Process Change Notification

Title: MCC Introduces Auto-Soldering Process For SOD-123FL Package

PCN#: 080115-1

Qualification Data and summary:

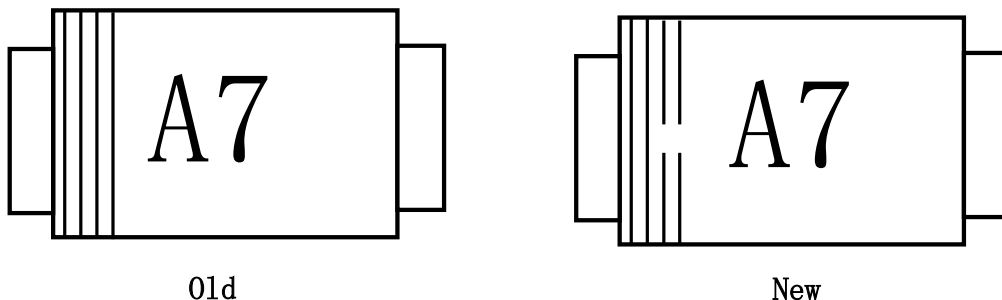
Devices were randomly selected by different power ratings.
